# PlanGrid Task Report - Aug 1, 2024

19 tasks in this report.

## #352 [UNIT 510][NEW] AC-1 Gas Inlet Grommet

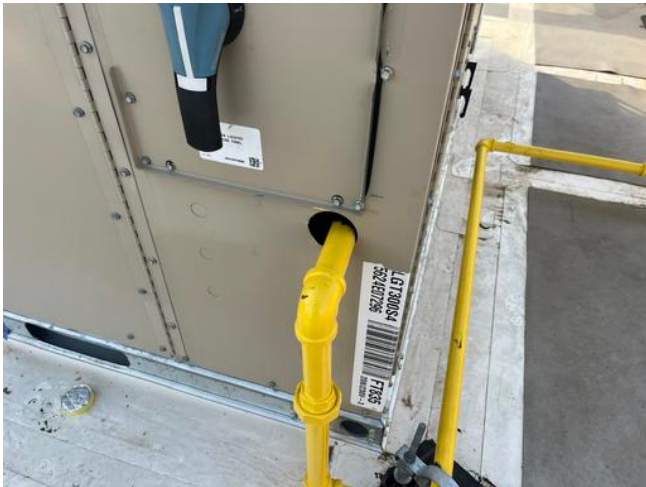
AC gas inlet grommet is missing at the gas line/RTU connection.

## #350 [UNIT 504][NEW] Equipment Fresh Air Tempering

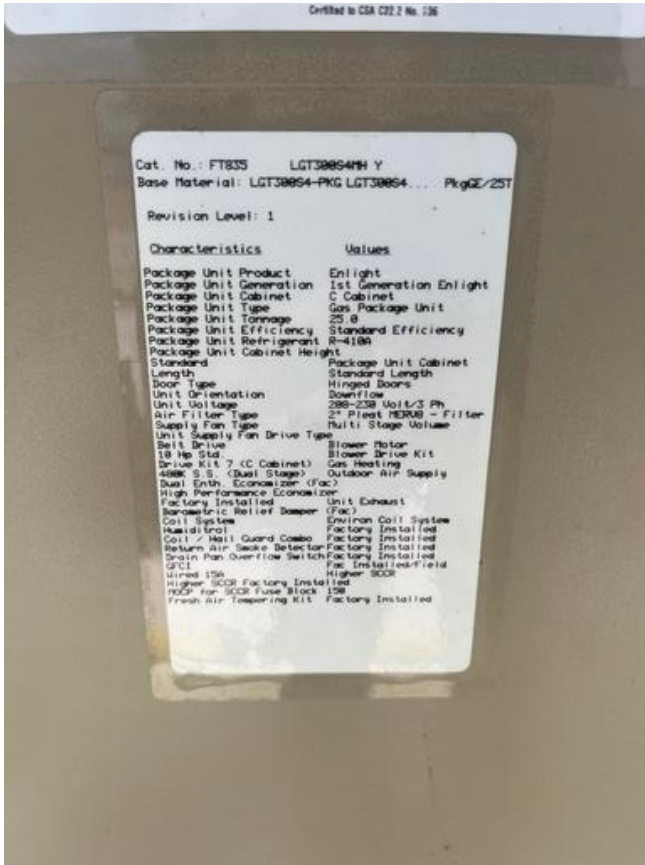
All ACs are to have FAT per schedule. Discharge sensors still need to be installed per specification on ACs 1,2, and 5. Lennox parameters set, but recommend verification.

**Sheet**  
P4.1

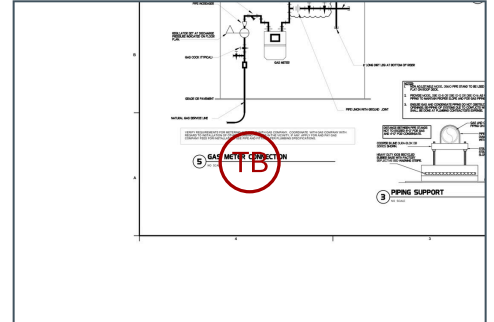
**Description**  
See condensate specs. T-  
fitting open to atmosphere  
needs to be below  
connection to AC unit.
